**ADDENDUM NO. 3**  
**NEWPORT TRANSFER STATION EXPANSION**  
**CARTERET COUNTY, NORTH CAROLINA**

**SUBJECT:** **ADDENDUM NO. 3.** Dated Tuesday, February 6, 2024, to Construction Documents for the Newport Transfer Station Expansion (REBID), dated December 8, 2023, and amended via Addendum No. 1 on January 19, 2024, and Addendum No. 2 on January 31, 2024.

**C-0010A**

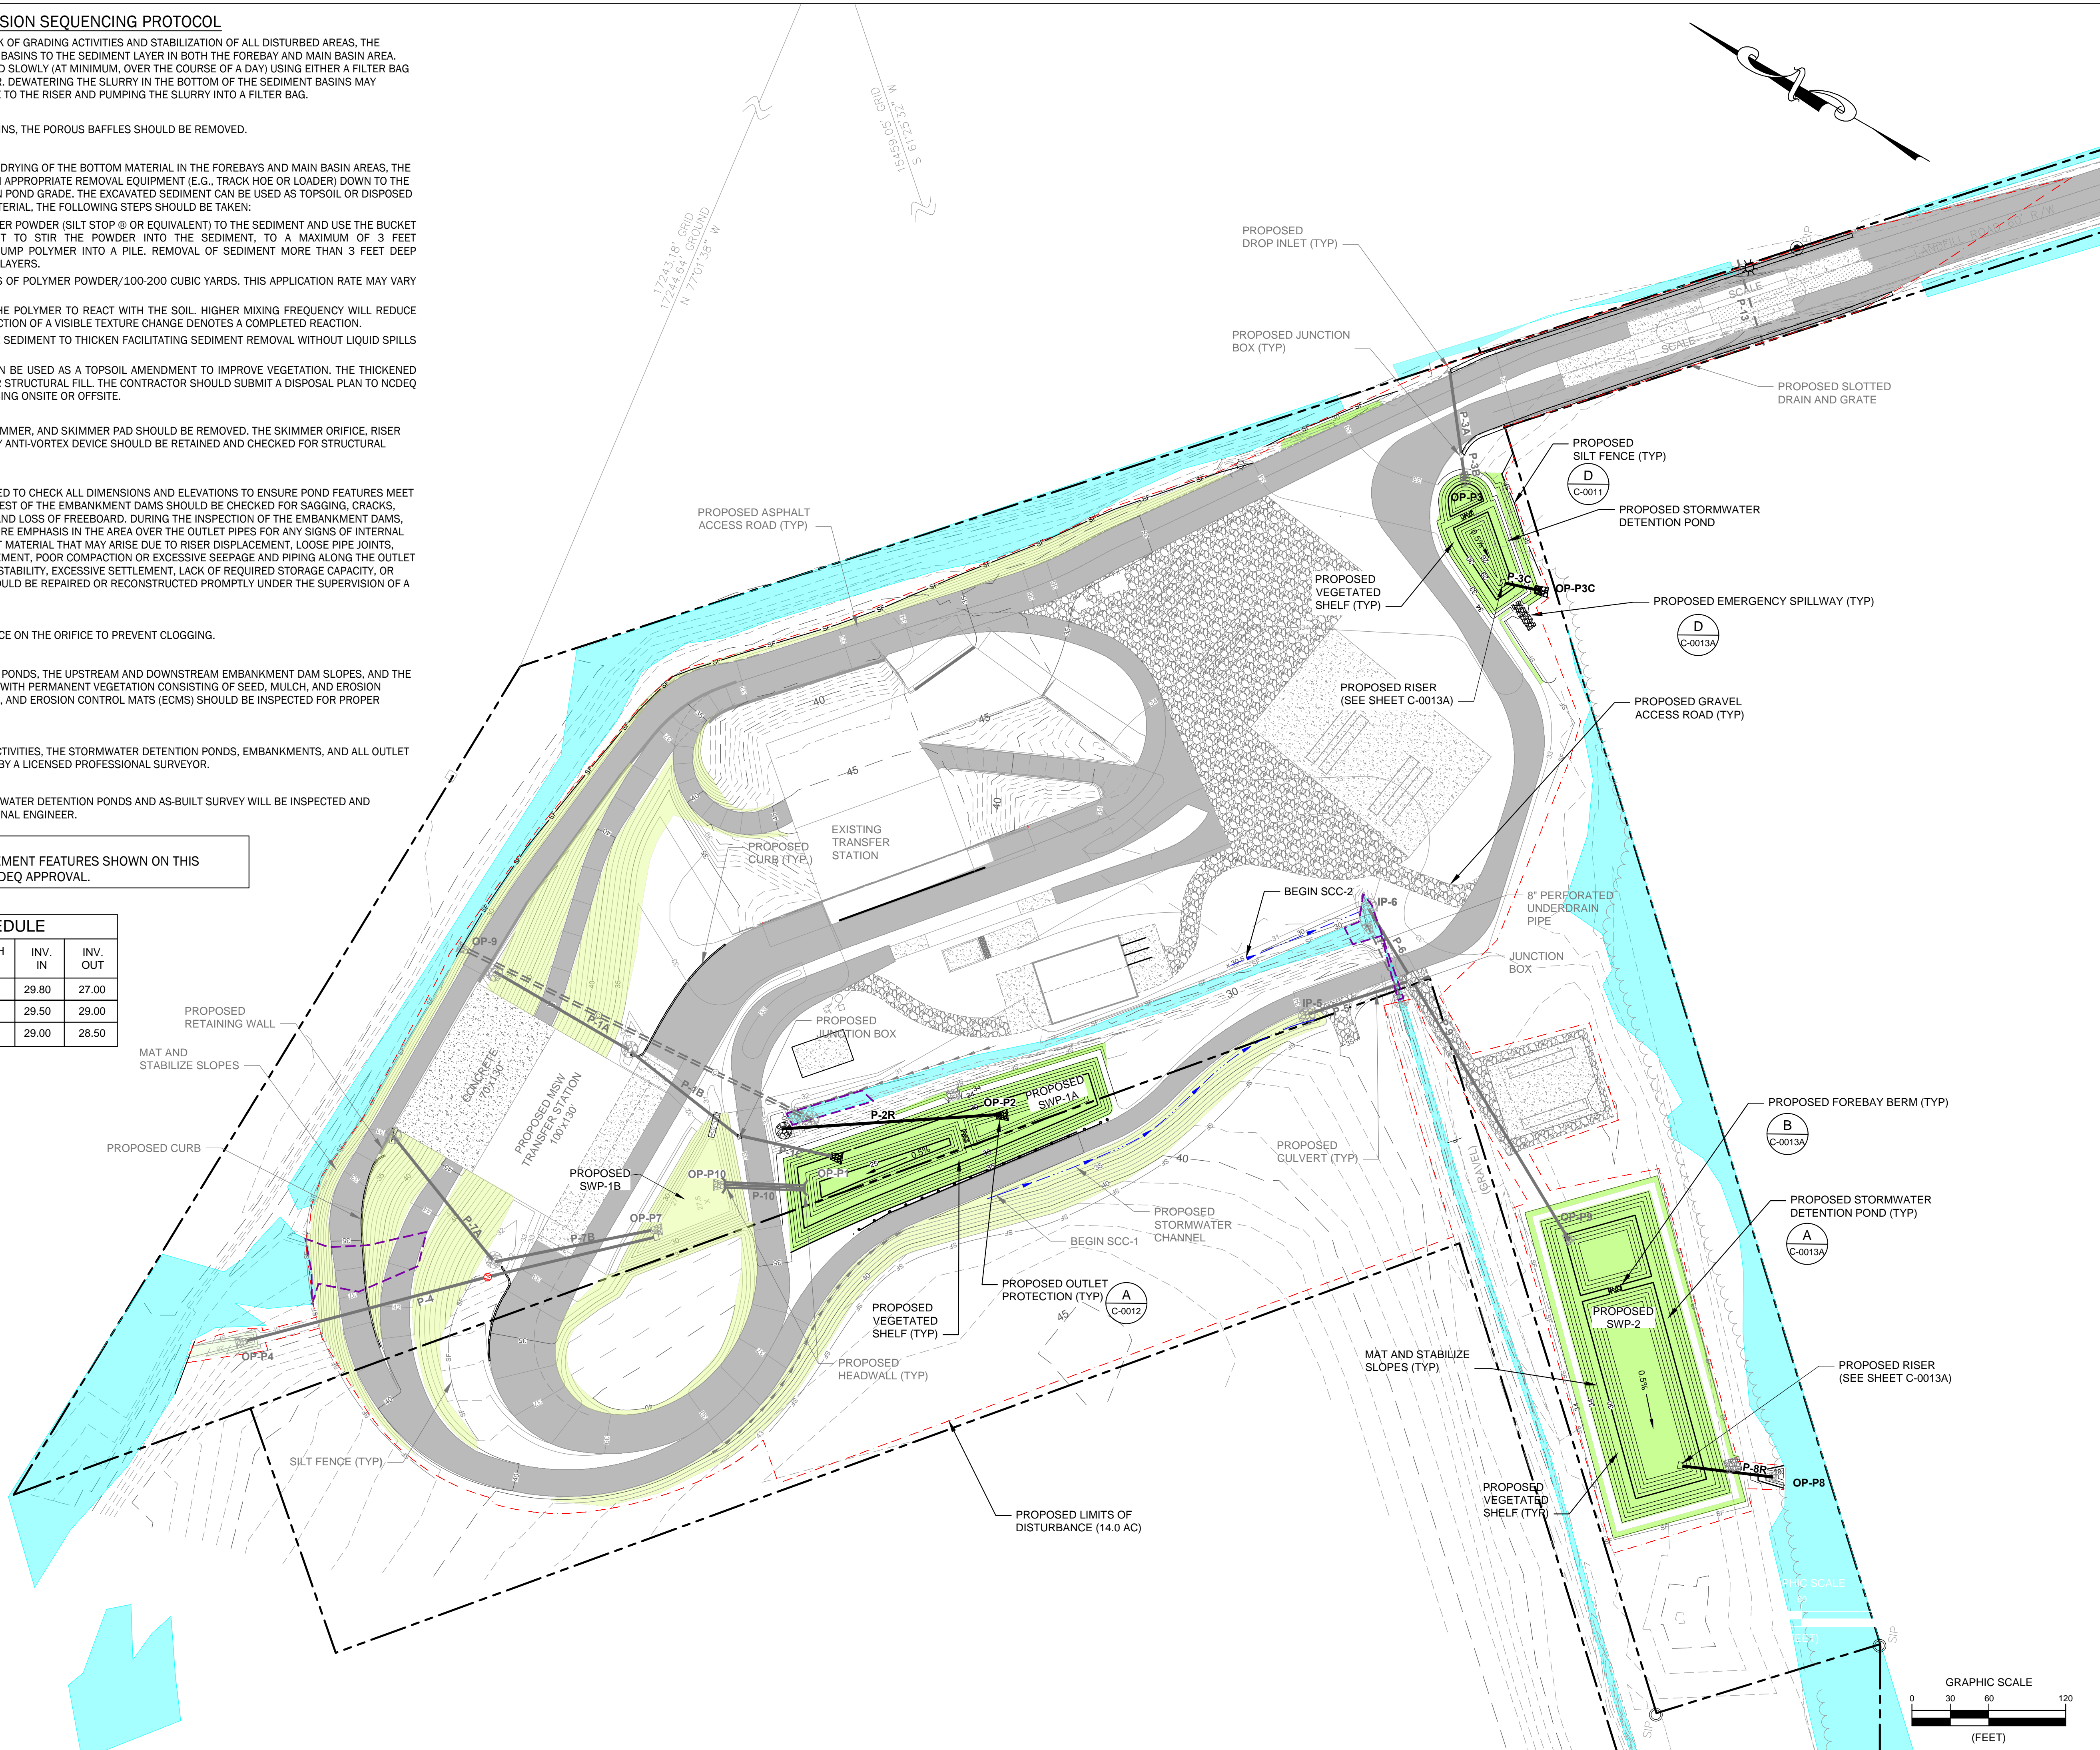
- A diversion berm, conveying water from the western road embankment to SCC-1, was added to Drawing No. C-0010.
- A new pipe, P-2R, was added. Refer to revised Drawing No. C-0010 and newly added Drawing No. C-0010A.

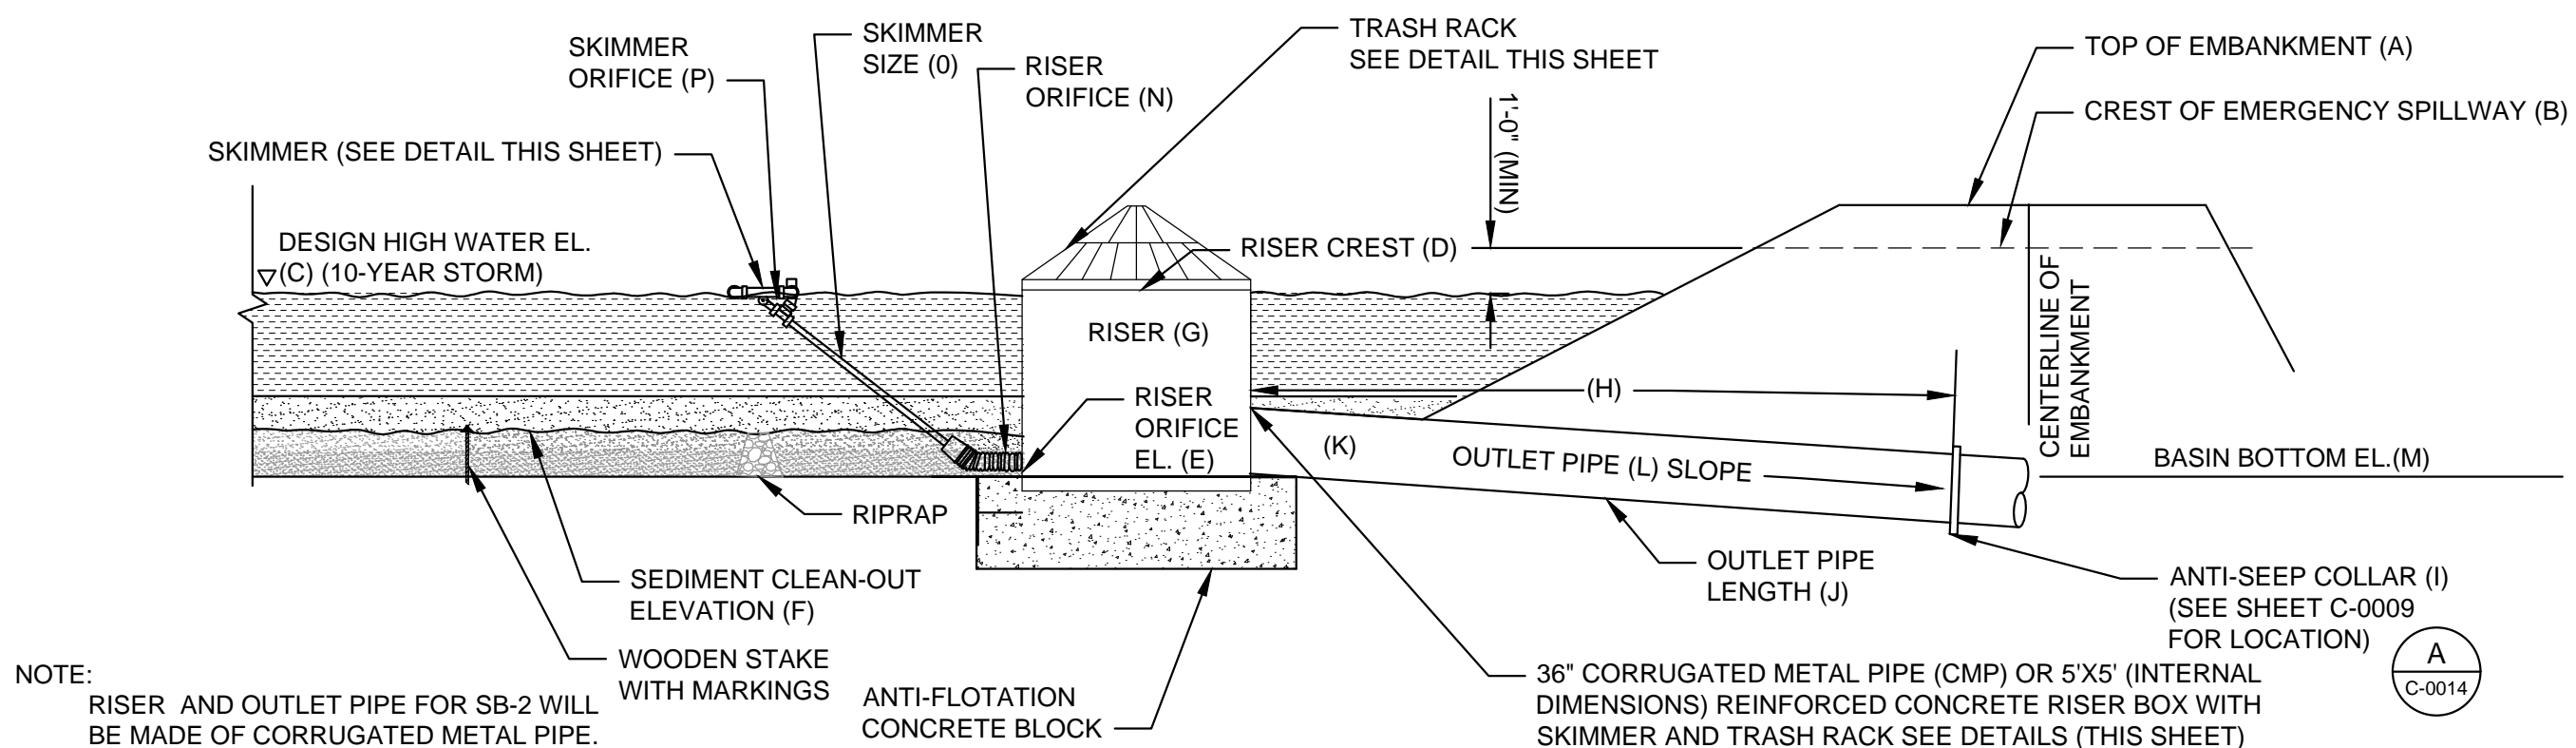
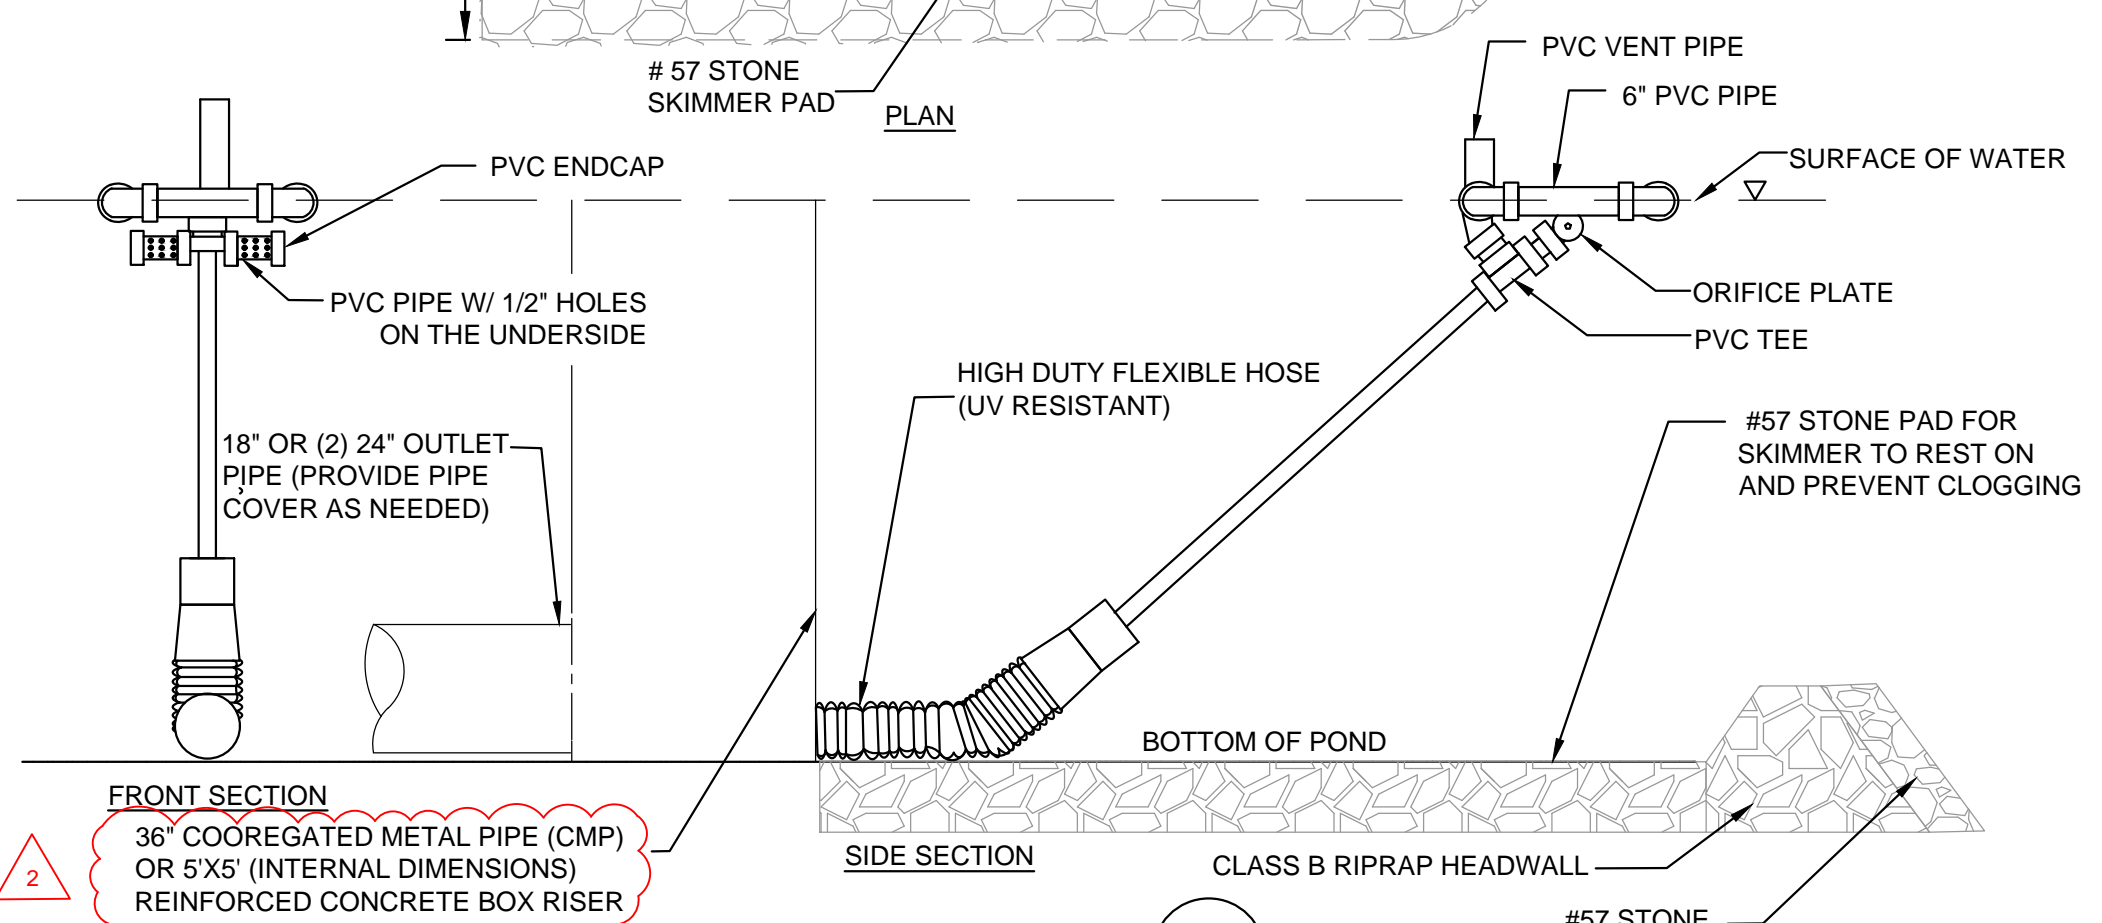
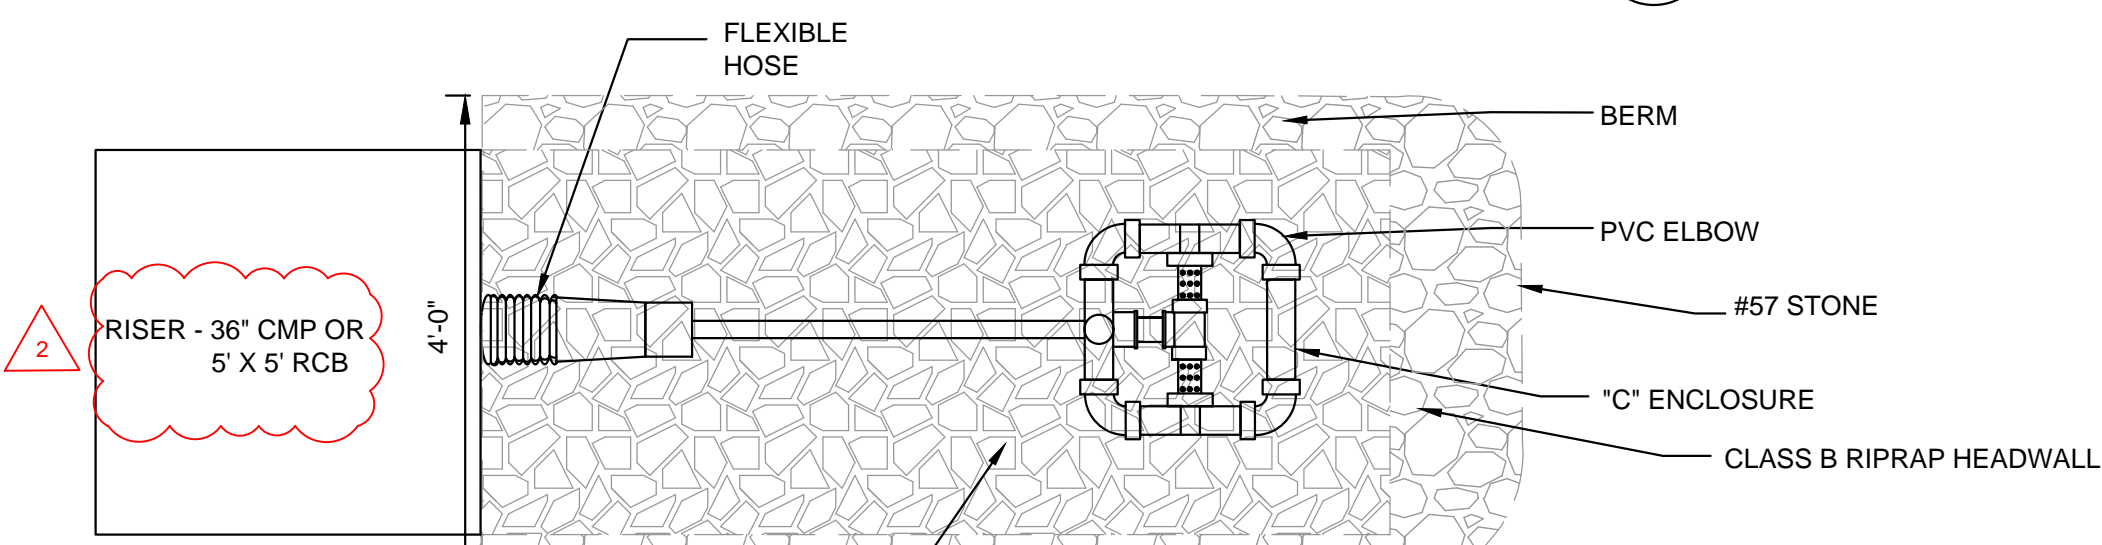
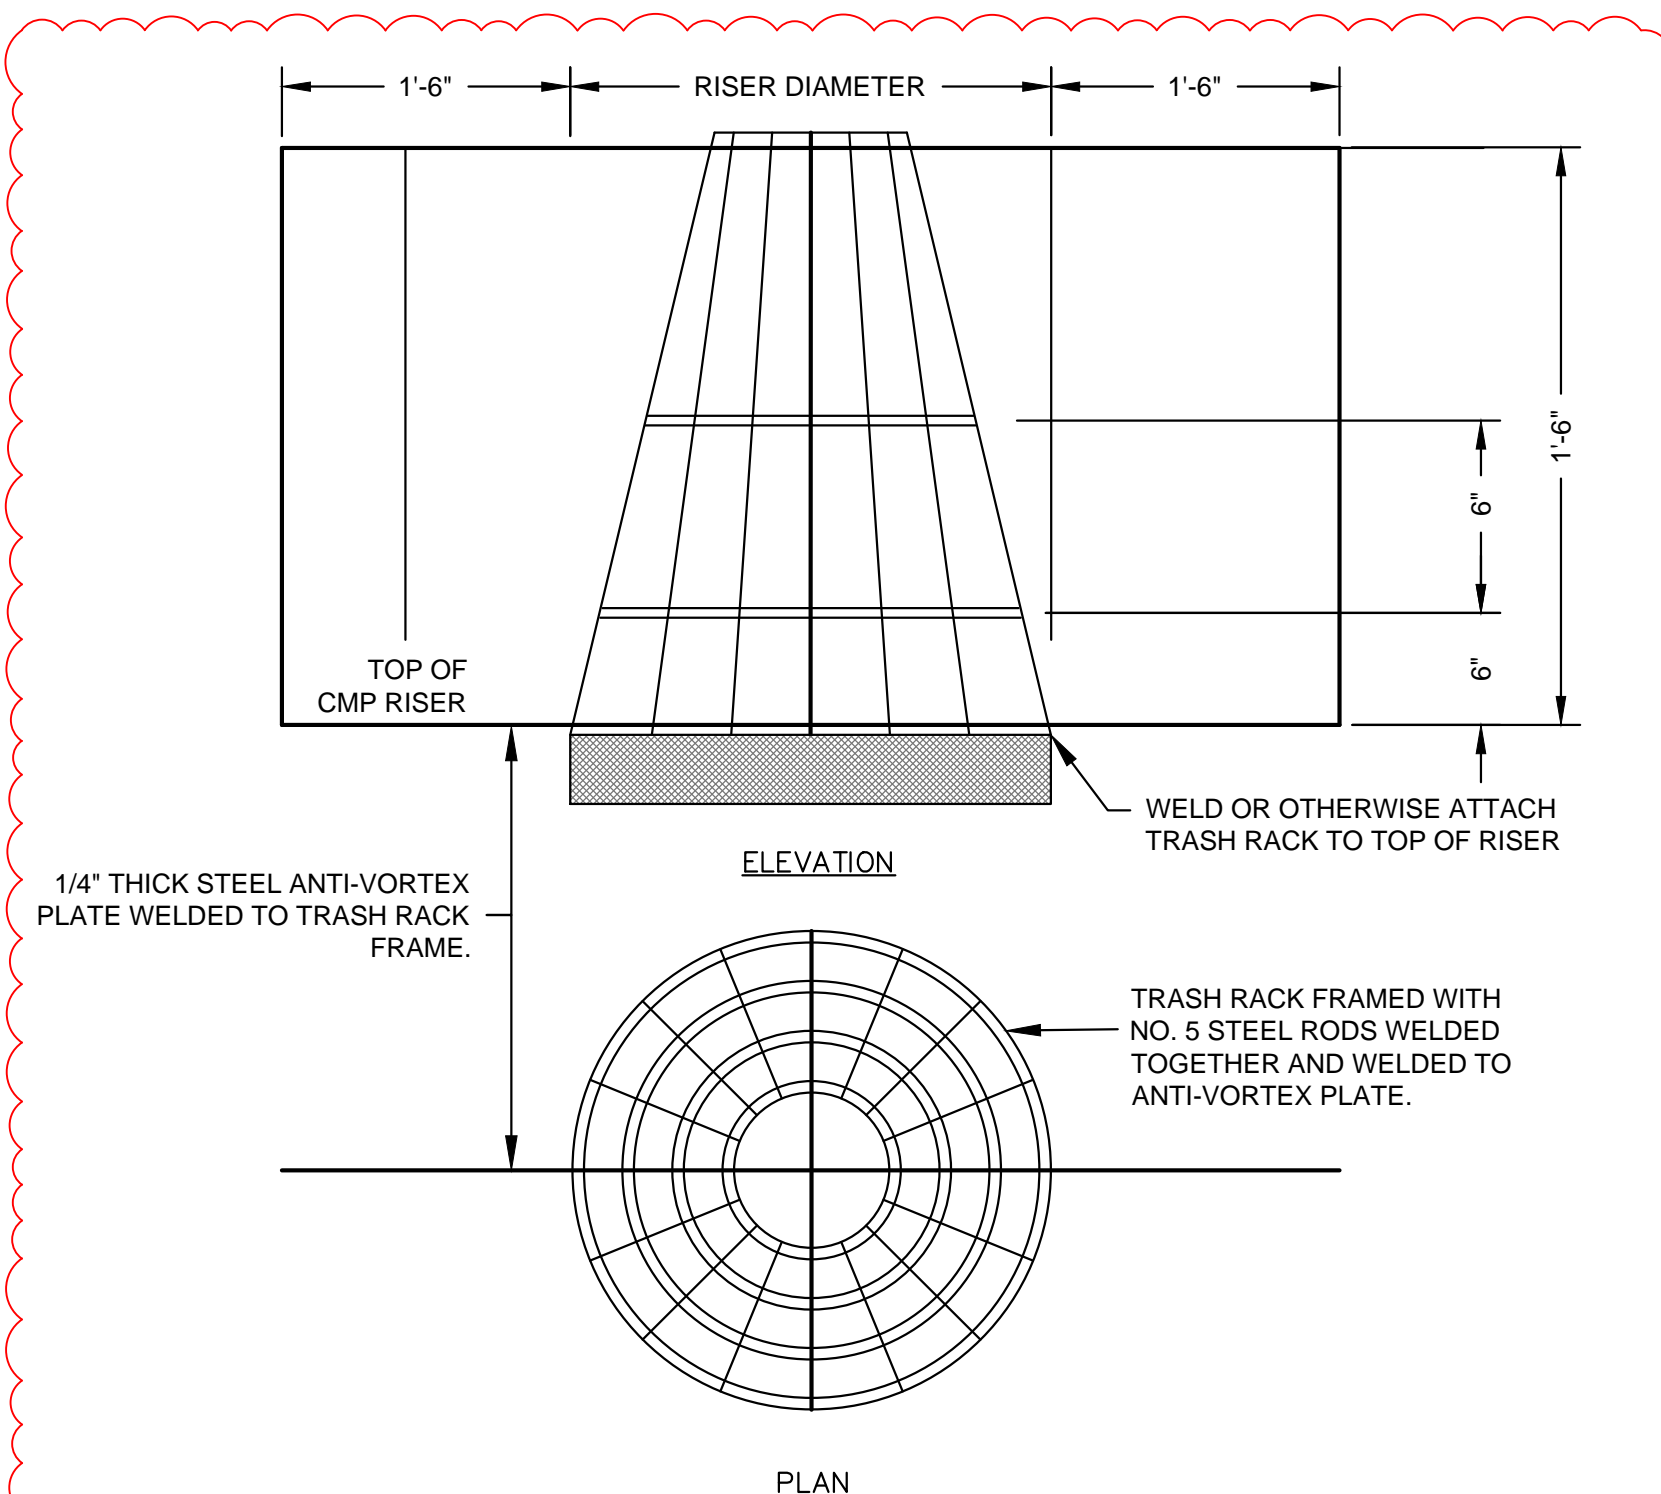
- The temporary riser and outlet structure for Sediment Basin (SB) 2 were changed from reinforced concrete pipes to corrugated metal pipe (CMP). This temporary riser structure and pipe will be replaced by a reinforced concrete riser box and outlet pipes during the conversion of the sediment basin to wet detention pond.
